SERVICE INSTRUCTION

RUNNING MODIFICATIONS ON

ROTAX® ENGINE TYPE 912/914 (SERIES)

SI-912-020R11

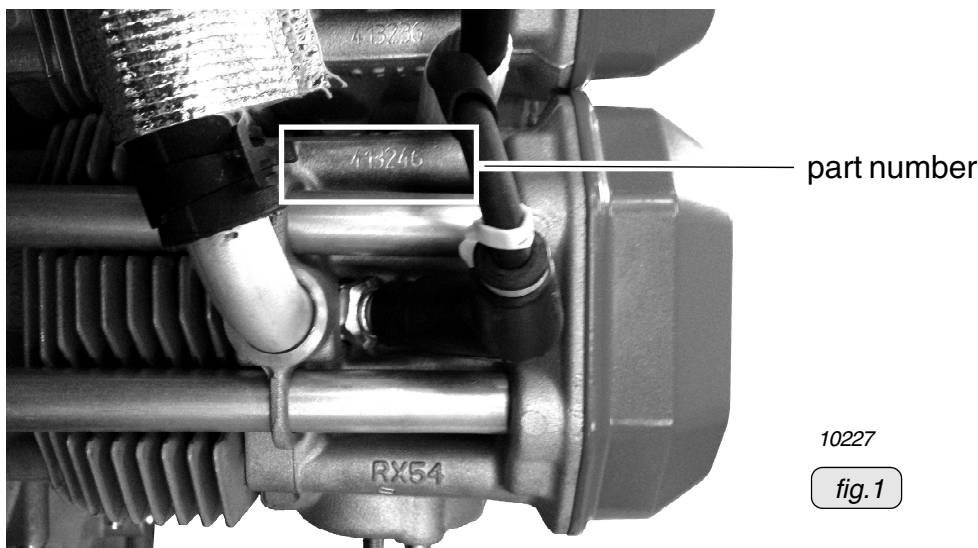
In the course of continuous development and standardization with ROTAX® 912 i Series, a new cylinder head with modifications in its mold has been introduced. Due to these changes the coolant temperature instead of the cylinder head temperature in the aluminium will be displayed. Check the temperature limit for the new positioned measuring point of the cylinder head displayed in the cockpit and if necessary correct its naming (measuring position) and limit.

◆ **NOTE:** Identifying new cylinder heads: The electrical connection of the temperature sensor is pointing upwards. New configuration see fig. 2. Old configuration see fig. 3.

Regarding change of position of the temperature sensor, see fig. 2 and fig. 3.

In case of a retrofitting/repair or overhaul, observe the installation and maintenance related changes. If a cylinder head of the new version is installed at the position of the temperature measurement, the sensor wiring may need to be changed due the new sensor position.

◆ NOTE: The temperature sensor part no. 965531 and its connection is not changed.

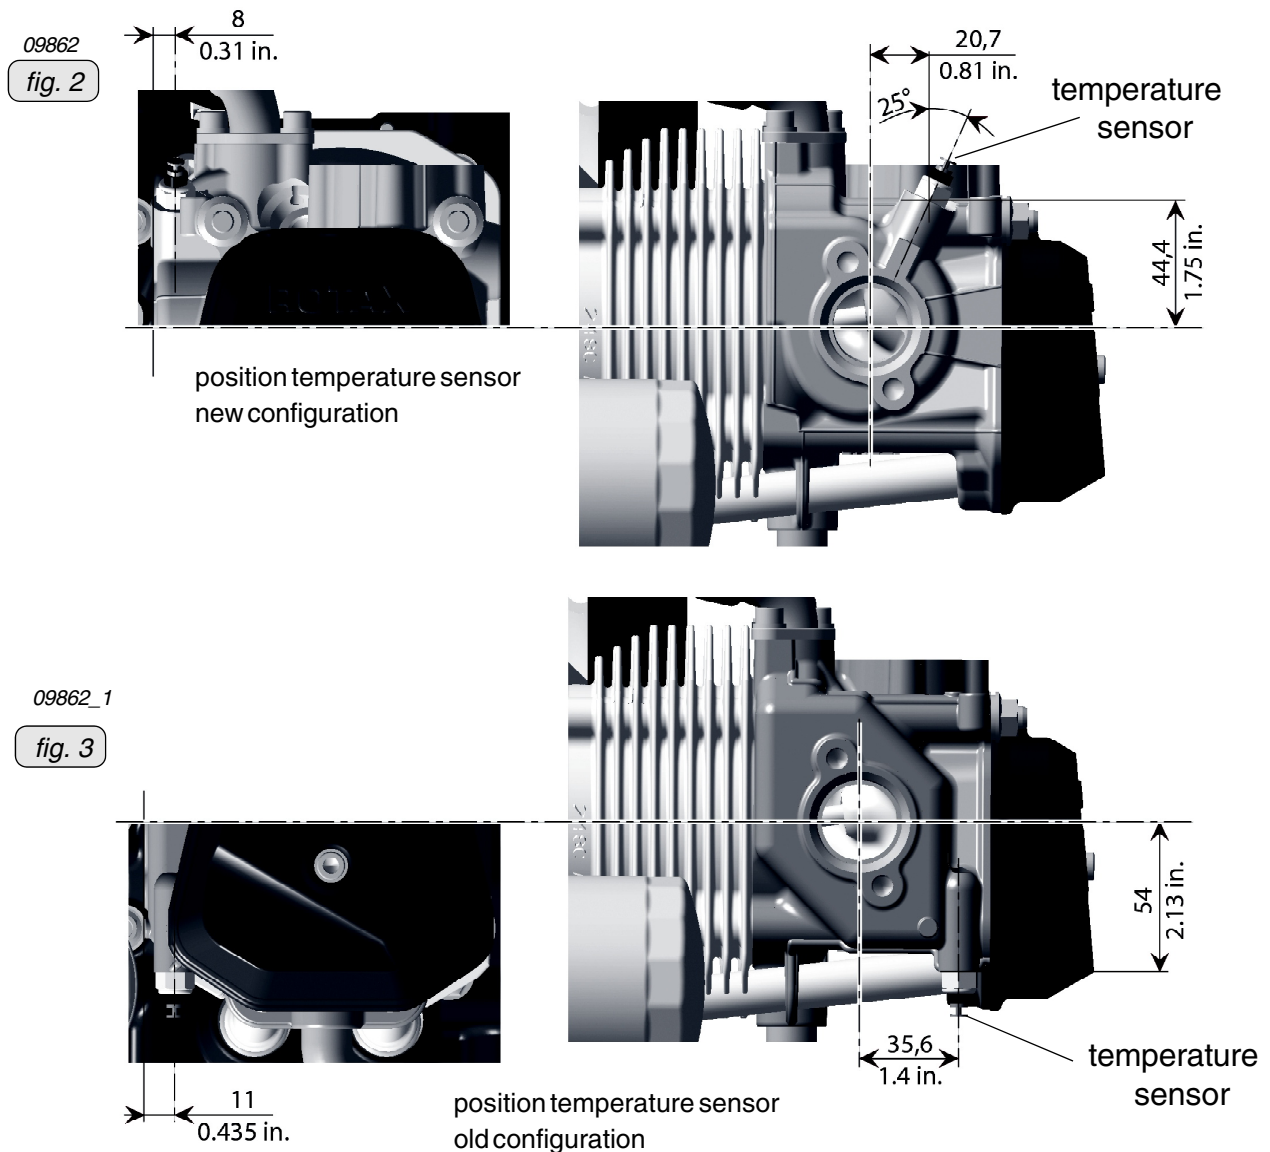
◆ NOTE: Contrary to the earlier design, the temperature sensor is directly flooded with coolant. Therefore the thread must be sealed with LOCTITE.

1. Clean the thread of the temperature sensor.
2. Apply LOCTITE 243 to the thread of the temperature sensor. Tightening torque 10 Nm (90 in.lb).
3. Plug the respective wiring harness connector into the temperature sensor.
4. Engine assembly.
5. Fill with operating fluids (coolant, oil or fuel). See also chapter 12-20-00 current issue of Maintenance Manual Line for the engine type 912/914 Series.
6. Conduct test run. See also chapter 12-20-00 current issue of Maintenance Manual Line for the engine type 912/914 Series.

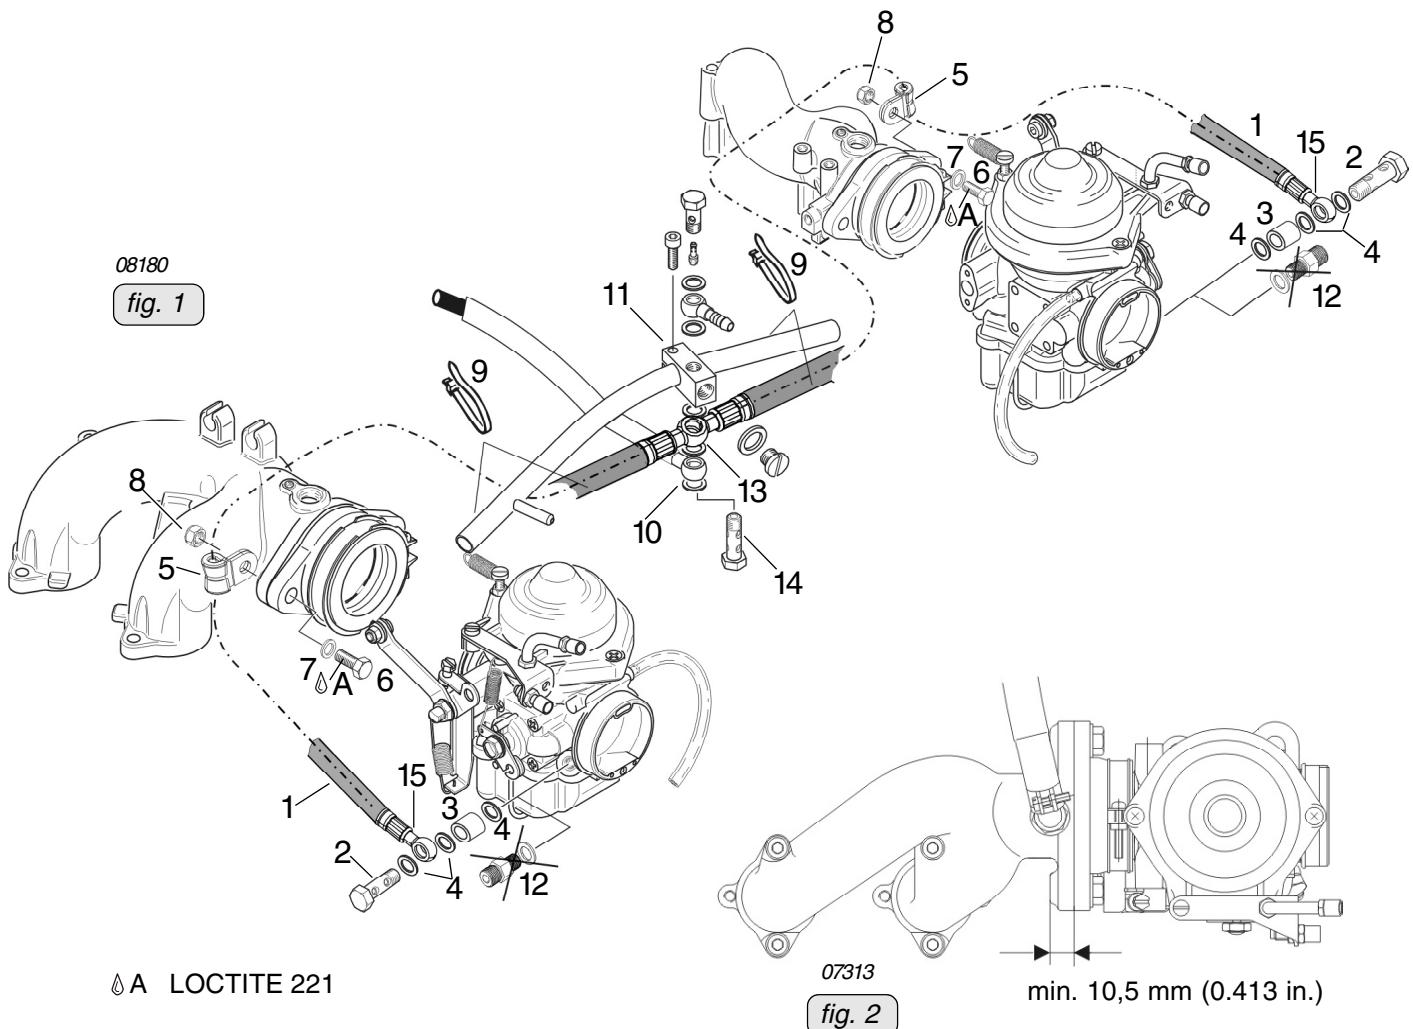
In the course of continuous development and for better assembly and maintenance a new flexible fuel line (part no. 874911) has been introduced.

- mechanical machining at the intake manifold for the attachment of the cable clamp. At engine repair/general overhaul be aware that the fixation of the flexible fuel line needs an appropriate contact surface. If necessary replace the intake manifold or machine the contact surface according to the following instruction.

- For installation on an old style intake manifold perform the following: Remove the intake manifold and machine the nut/clamp contact area until the surface is parallel with the sealing surface of the carb socket. The thickness of the material must not be dressed down less than 10,5 mm (0.413 in.) and should be smooth and flat so that the nut/clamp assembly has an even contact surface (see fig. 2).

- Install the flexible fuel line (1) with the double ring hose nipple (13) and sealing ring (10) on the clamp block (11). Tightening torque of banjo screw (14) 10 Nm (90 in. lb.) (see fig. 1).
- Install the ring hose nipple (15) with distance sleeve (3) and sealing ring (4) on the carburetors. Tightening torque of banjo screw (2) 10 Nm (90 in. lb.)

- Ensure proper support of the flexible fuel line. Install Hex. screw (6) and washer (7) with 15 Nm (133 in. lb.). Install the cable clamp (5) at the hex. screw (6) of the carburetor socket with the hex. nut (8). Tightening torque of hex. nut (8) 24 Nm (213 in. lb.)

■ **CAUTION:** While tightening hex. nut (8), hold hex. screw (6) with a wrench to prevent it from loosening. Always fix the flexible fuel line at the compensation tube with clamps (9) in such a way that no chafing is possible.

08353
fig. 1

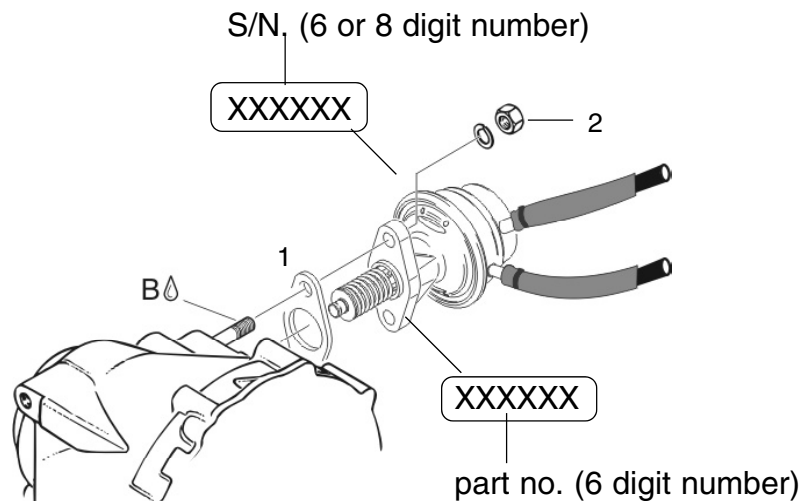
In the course of continuous development a new gasket (1) (part no. 950226) has been introduced.

The gasket is interchangeable.

- ◆ NOTE: On the sealing surfaces of the gearbox housing and the fuel pump no sealing compound has to be used.

fig. 2

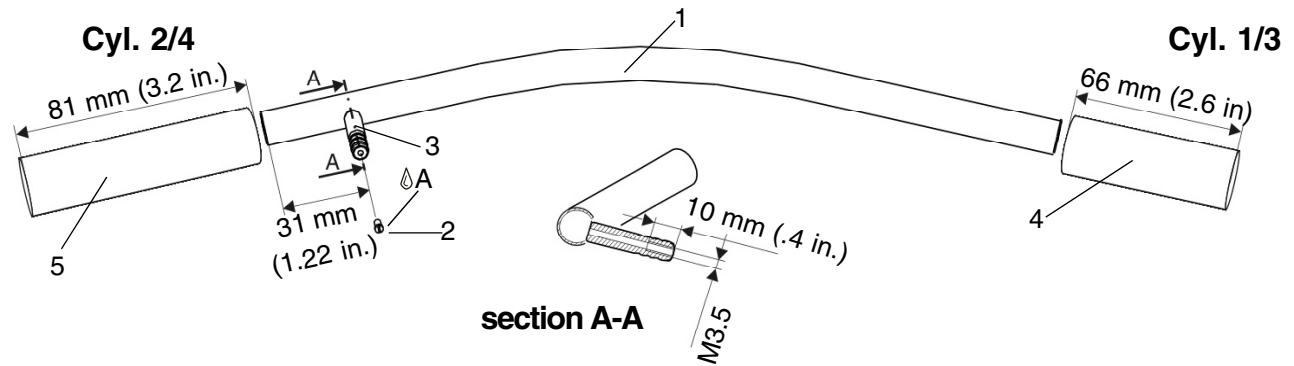
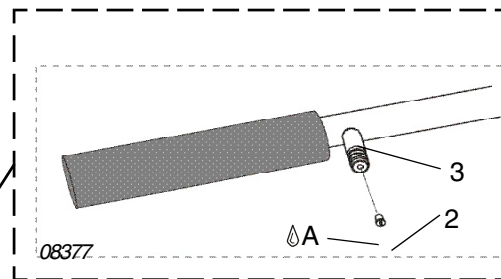
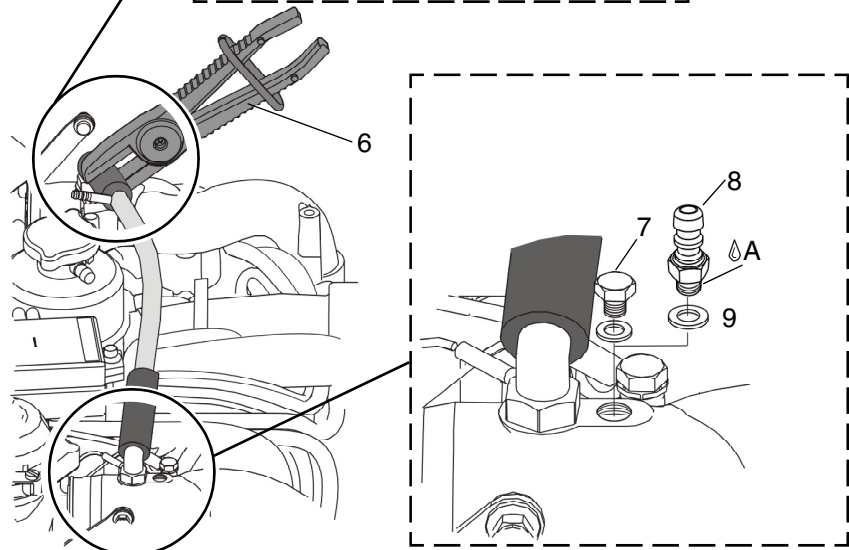
In the course of continuous development a new compensation tube (1) (part no. 924541) has been introduced which need not be removed during carb synchronization, making the process easier to perform.

- position of connection fitting (3) on compensation tube remains approximately constant
- additional screw (2) part no. 940980 for connection fitting (3)
- new tube (4) part no. 956143 (5) part no. 956141

1. Install the vacuum gauge.
2. Clamp the tube with hose clamping pliers (6). Observe the position! The tube (1) must not removed.
3. Unscrew the screw (7).
4. Install the hose nipple M6 (8) with the sealing ring (9).
5. After synchronization tightened the screw M6x6 (7) with LOCTITE 221.

◆ **NOTE:** If it is not possible to stabilize the intake manifold pressure, tighten the screw M3.5x6 (2) with LOCTITE 221. Install color markings on the screw.

fig. 1

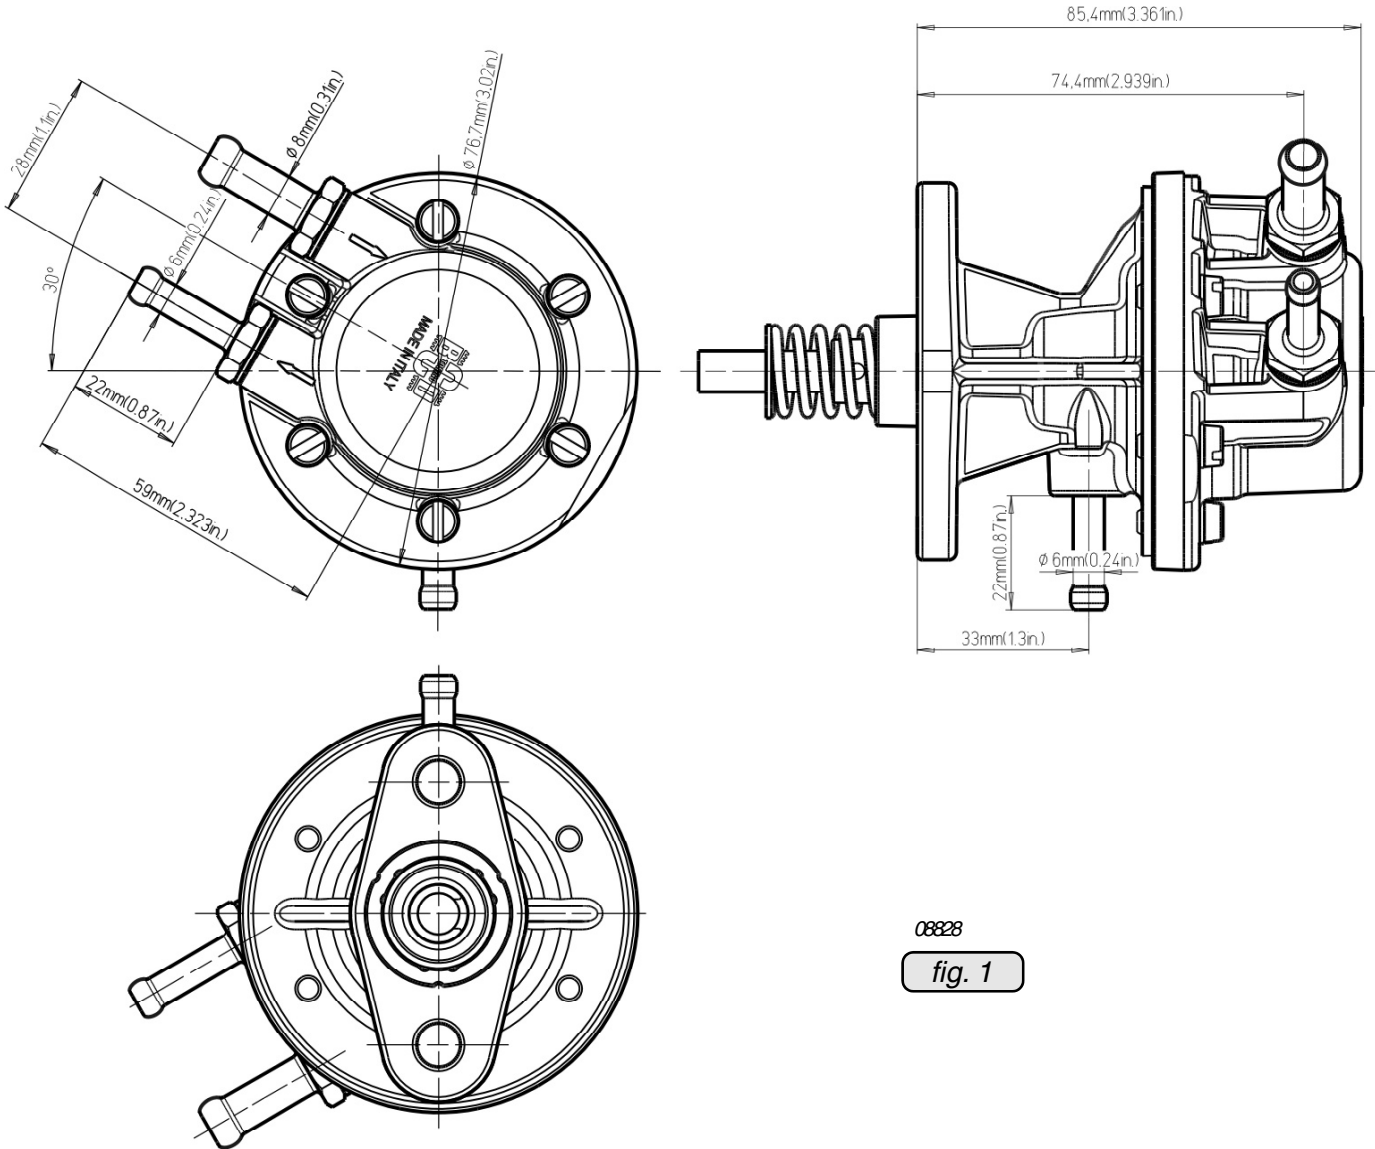
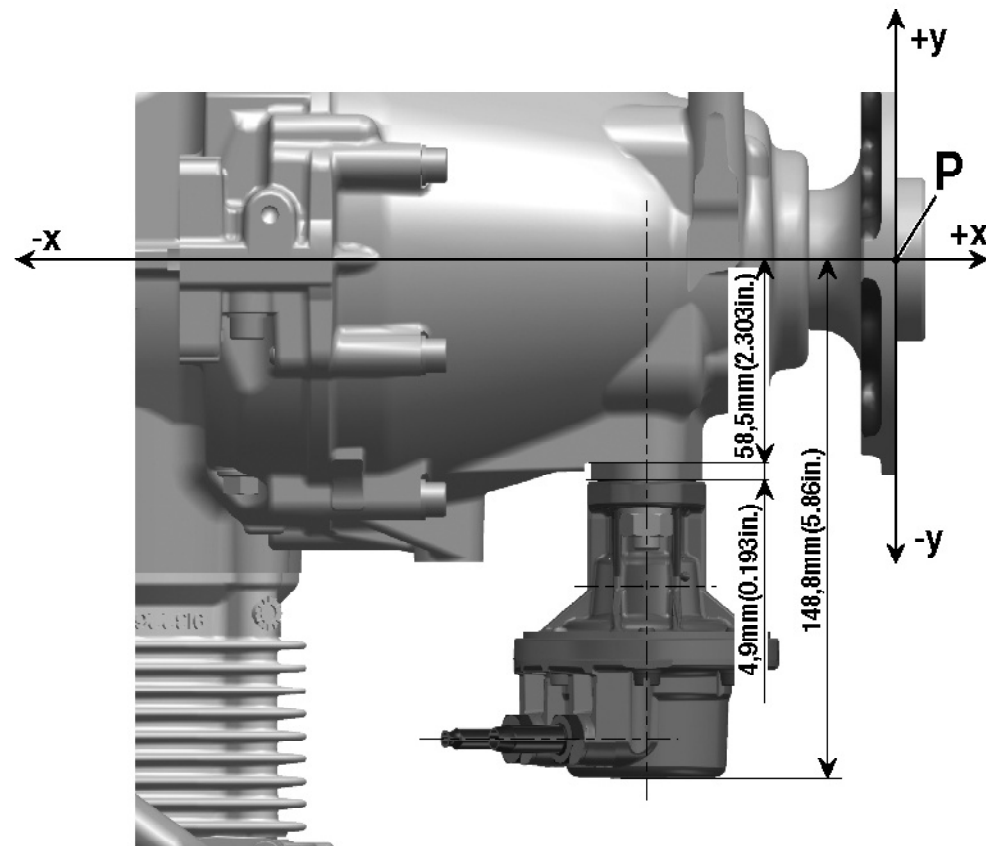
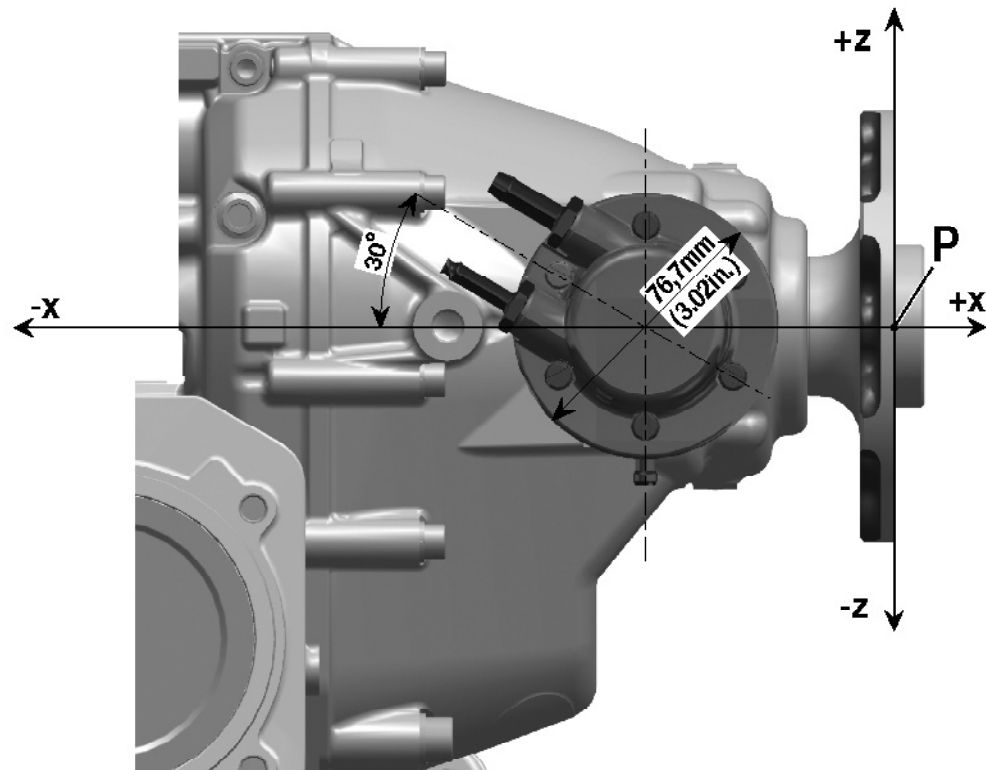
In the course of continuous development a new fuel pump assy. (part no. 893110 and/or part no. 893114) has been introduced.

In the course of standardization a new "basic" fuel pump assy. (part no. 893115) has been introduced, which can be configured with the appropriate nipples or fuel hoses.

- ◆ NOTE: In case of an upgrade the parts listed above have to be used, the fuel pump must be installed using the new isolating flange (gasket). Amendments concerning service or installation need to be adhered to. Proof of certification to the latest requirements such as FAR or EASA has to be supplied by the aircraft manufacturer.
